HN-223
DN-168
EN-59
FN-47

SERVICE BULLETIN

SUBJECT: ONE-TIME REPLACEMENT OF POLYCARBONATE COVER ASSEMBLES (369A9817)

Figure 1. Fabrication of 369A9817-11 Cover Assembly.

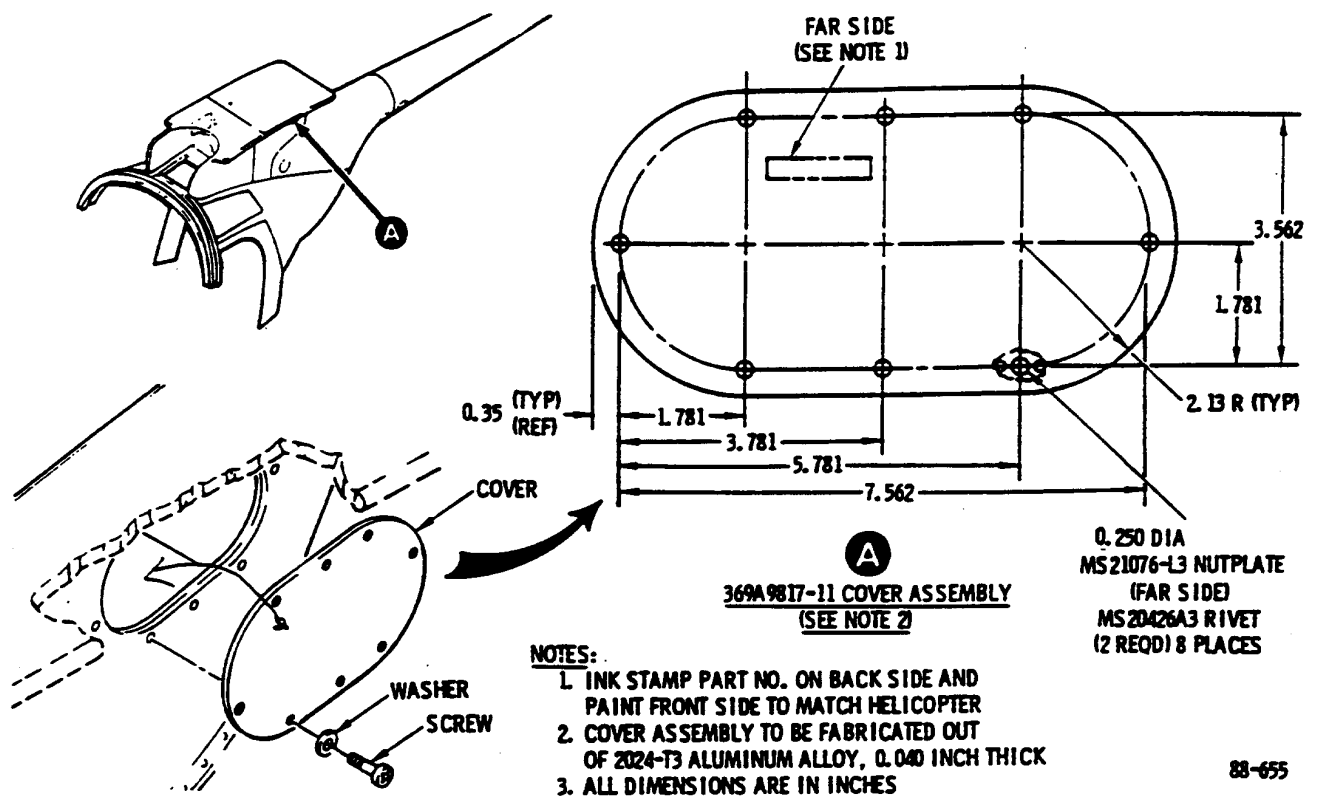
SUMMARY: MD Helicopters, Inc. (MDHI) has received reports that some 369A9817 polycarbonate cover assemblies were found cracked by visual inspection.

Complete failure of the cover assembly could result in severe FOD damage to the engine.

PURPOSE: It is the purpose of this Notice to replace all polycarbonate cover assemblies with aluminum cover assemblies.

369A9817(BSC) cover assemblies are polycarbonate and 369A9817-11 cover assemblies are aluminum.

- Discard polycarbonate cover assemblies and procure a 369A981 7-11 cover assembly from MDHC Warranty and Repair Dept. or field fabricate a 369A981 7-11 cover assembly per instructions in Figure 1.

Nutplates may be removed from polycarbonate cover assemblies and reused for fabricating an aluminum cover assembly.

- Prime and paint cover assembly accordingly.
- Install aluminum cover assembly using existing screws and washers.
